Hardin Park

Assessment October 23, 2018

ADA Checklist for Existing Facilities

Building: Hardin Park Kiwanis Pavilion

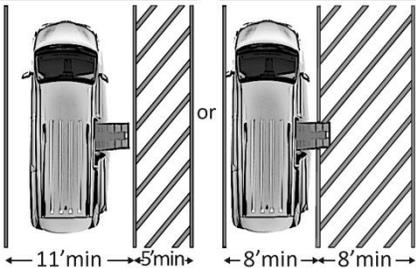
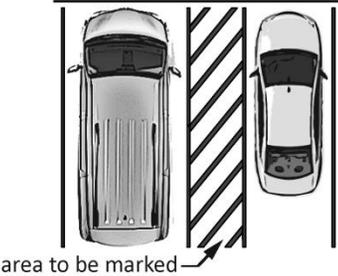
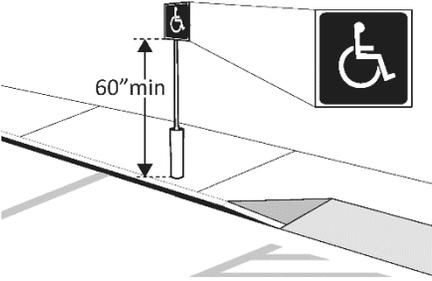
1.3 Of the accessible spaces, is at least one a van accessible space?*[208.2.4]

No

- Reconfigure by repainting lines

Budget Year: 2021 Cost: \$250
<p>1.4 Are accessible spaces at least 8 feet wide with an access aisle at least 5 feet wide? [502.2, 502.3]</p> <p>Note: Two spaces may share an access aisle. Check state/local requirements; some specify that each space have its own aisle.</p>	<p>Yes</p> <p>Measurement:</p>	 <p>← 8' min → 5' min →</p>	Photo #:	
<p>1.5 Is the van accessible space:</p> <p>At least 11 feet wide with an access aisle at least 5 feet wide? Or At least 8 feet wide with an access aisle at least 8 feet wide? [502.2]</p>	<p>No</p> <p>Measurement:</p> <p>No</p> <p>Measurement:</p>	 <p>← 11' min → 5' min → or ← 8' min → 8' min →</p>	Photo #:	<ul style="list-style-type: none"> • Reconfigure to provide van-accessible space(s) • Re paint the lines <p>Budget Year: 2021 Cost: \$500</p>
<p>1.7 Are the access aisles marked so as to discourage parking in them? [502.3.3]</p> <p>Note: The marking method and color may be addressed by state/local requirements.</p>	<p>Yes</p>	 <p>area to be marked</p>	Photo #:

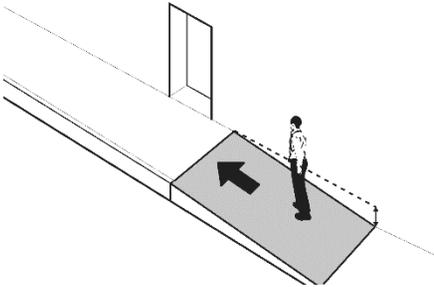
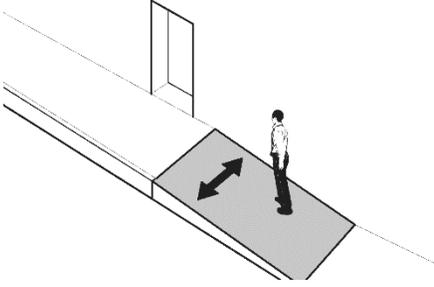
<p>1.8 Is the slope of the accessible parking spaces and access aisles no steeper than 1:48 in all directions? [502.4]</p>	<p>Yes Measurement:</p>		<p>Photo #:</p>	
<p>1.9 Do the access aisles adjoin an accessible route? [502.3]</p>	<p>Yes</p>		<p>Photo #:</p>	
<p>1.10 Are accessible spaces identified with a sign that includes the International Symbol of Accessibility? Is the bottom of the sign at least 60 inches above the ground? [502.6]</p> <p>Note: The International Symbol of Accessibility is not required on the ground.</p>	<p>No NA Measurement:</p>		<p>Photo #:</p>	<ul style="list-style-type: none"> • Install signs <p>Budget Year: 2020</p> <p>Cost: \$100</p>
<p>1.11 Are there signs reading “van accessible” at van accessible spaces? [502.6]</p>	<p>No</p>		<p>Photo #:</p>	<ul style="list-style-type: none"> • Install signs <p>Budget Year: 2020</p> <p>Cost: \$100</p>
